NOTICE OF DECISION

SUBDIVISION / URBAN GROWTH PRELIMINARY DECLARATION
CASE NO.: SUB-UGA18-01

REQUEST: A tentative subdivision plan and Urban Growth Preliminary Declaration to divide approximately 4.82 acres into 20 lots ranging in size from 5,711 square feet to 11,466 square feet.

**TENTATIVE SUBDIVISION
PLAN
DETAIL PLAN**

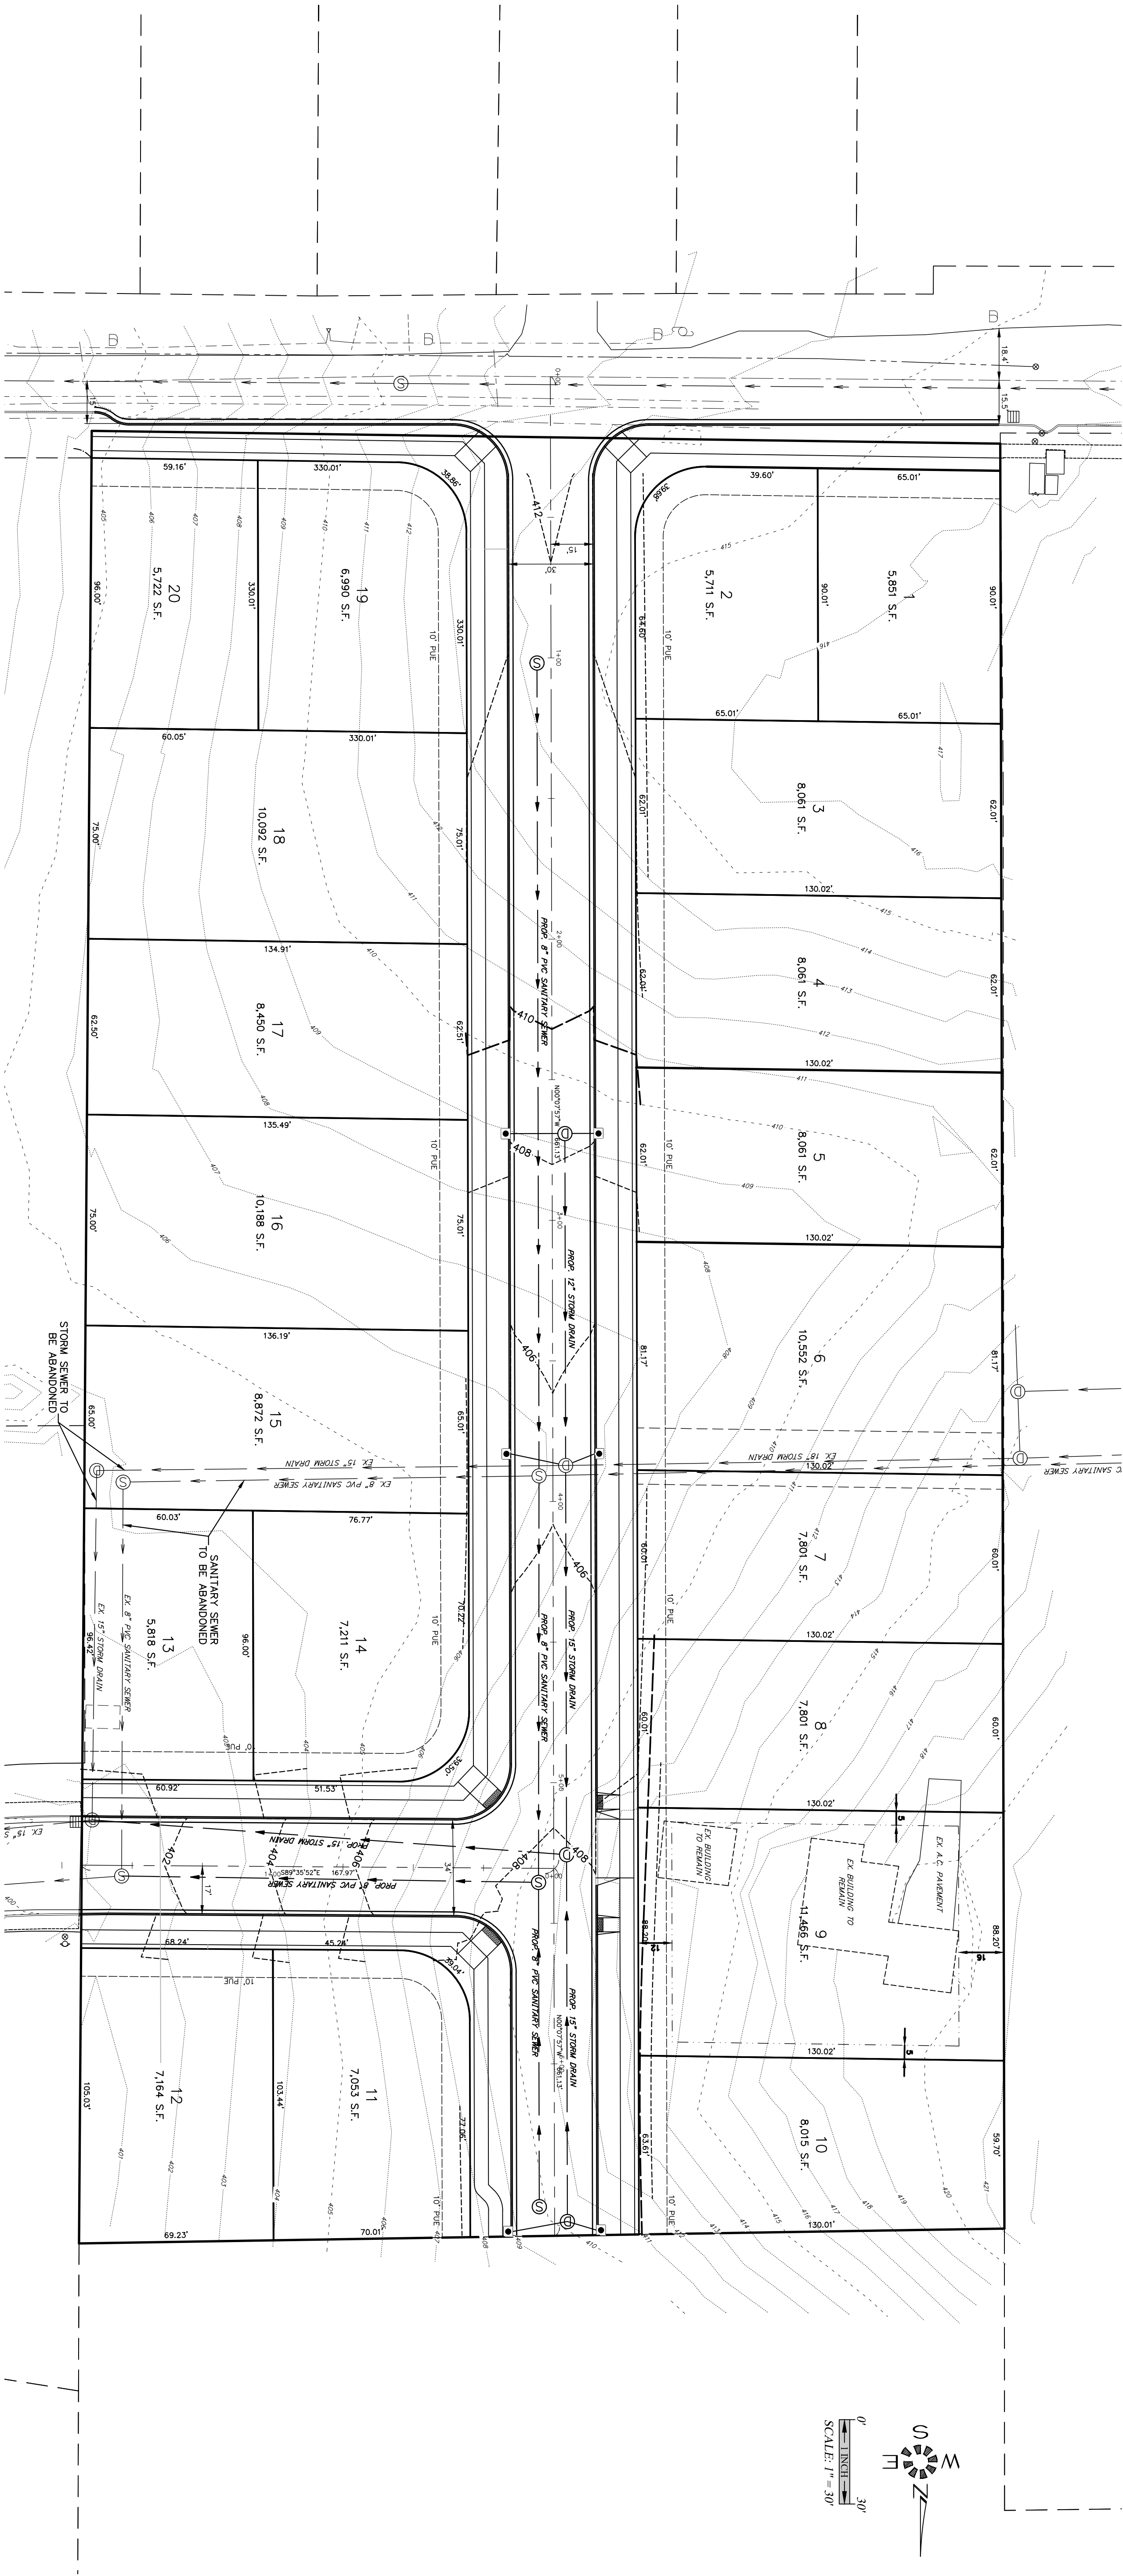
The applicant has not addressed how Lot 9 is proposing to retain an existing accessory structure, which will not meet the required setback to the front property line. As shown on the applicant's tentative plans, the application does not meet the setback standards for the existing accessory structure proposed to remain.

However, based on the existing development pattern in the vicinity, the proposed subdivision is not precluded from making connections to adjacent properties due to physical conditions or existing development that would make the connection unfeasible, and would meet the requirement under SRC 803.030(a) with an additional connection to the east. Additionally, not requiring the east connection would commit the adjacent property to a cul-de-sac development. The Salem Transportation System Plan (TSP) contains adopted goals, policies and objectives related to local street connectivity. The TSP states that "there are many existing cul-de-sacs in the City and streets that were constructed without due consideration to connectivity" and that "it is the intent of this...Plan to ensure that those connections are made and that new developments provide adequate connections to neighboring undeveloped land." The street connectivity standards in SRC 803.035(a) implement the adopted City policies for connectivity. Therefore, due to the lack of connectivity to the undeveloped property to the east, the proposal does not meet the connectivity under SRC 803.035(a).

At this time, abutting property to the east remains undeveloped. The tentative subdivision plan does not provide a connection to future development of the property. Pursuant to SRC 803.035(a), connections to the existing or planned streets and adjoining undeveloped properties shall be provided at no greater than 600-foot intervals. Providing connection to Brewer Street SE and the vacant property to the east would meet the standard of less than 600-foot intervals. If the connection the east is made, these street connections could be approximately 200 feet apart, ensuring that properties to the east can be developed in the future and also meet the 600-foot maximum block length set forth in SRC 803.030(a).

The applicant has not provided a connection to the residential property to the east nor to the vacant multi-family land to the west. Pursuant to SRC Chapter 803.035(a), connections to the existing or planned streets and *adjoining undeveloped properties* shall be provided at no greater than 600-foot intervals. The applicant provides findings that the street connection to Brewster Avenue SE is less than 600-feet from Boone Road, which does not required an additional connection to the vacant property to the east. As stated above SRC Chapter 803.025(a) requires connection to adjoining undeveloped properties and SRC Chapter 803.030 requires a maximum spacing of 600-feet. The Salem Revised Code does not prohibit multiple connections within a 600-foot interval. Providing a connection to the undeveloped property to the east would allow

Finding: Boone Road SE abuts the subject property and does not meet the current standard for local streets. The project includes the extension of Brewer Street SE from the east, but does not include a connection to the undeveloped property to the east. Pursuant to SRC 803.035(a), a street connection is warranted to the easterly adjoining undeveloped property. A connection located in the vicinity of lots 16 and 17 would be required to meet the criteria. The connectivity is needed to provide efficient circulation for the future development of the adjacent parcels.

Finding: The abutting portions of Boone Road SE is designated as a local street and is currently substandard. The applicant is proposing internal circulation which would be provided by extensions of Brewer Avenue SE, but would not provide for circulation to the undeveloped property to the east or west of the subject property.

The proposed tentative subdivision plan does not provide connection to the undeveloped property to the east. Without a connection from the proposed subdivision and the property to the east, the applicant is forcing the neighboring property to develop with a Cul-de-sac. Development of a Cul-de-sac on the undeveloped property to the east would prohibit efficient circulation and potentially unsafe turning movements. The abutting portion of Boone Road is designated as a local street although west of Liberty and east of Reed Road, Boone Road is designated a Collector Street. Boone Road does carry traffic east and west for those who are avoiding Kuebler Blvd. As proposed the subdivision would add unnecessary turning movements from the undeveloped property to the east (with a forced cul-de-sac development) trying to move north through the subject property. The additional turning movements do not provide for safe, orderly and efficient circulation. In addition, pedestrians would be safer walking through a

The application proposes a street connection to the undeveloped property to the north and a street connection to Brewster Avenue SE to the east. However, another street connection is warranted to the easterly adjoining undeveloped property. SRC 803.035(a) states, "Local streets shall be extended to adjoining undeveloped properties for eventual connection with the existing street system." This connectivity is required to provide efficient circulation for the future development of adjacent parcels. This application does not meet the connectivity requirements to adjoining undeveloped properties for eventual connection pursuant to SRC 803.035(a) and therefore does not meet the criteria for SRC 205.010(d)(5).
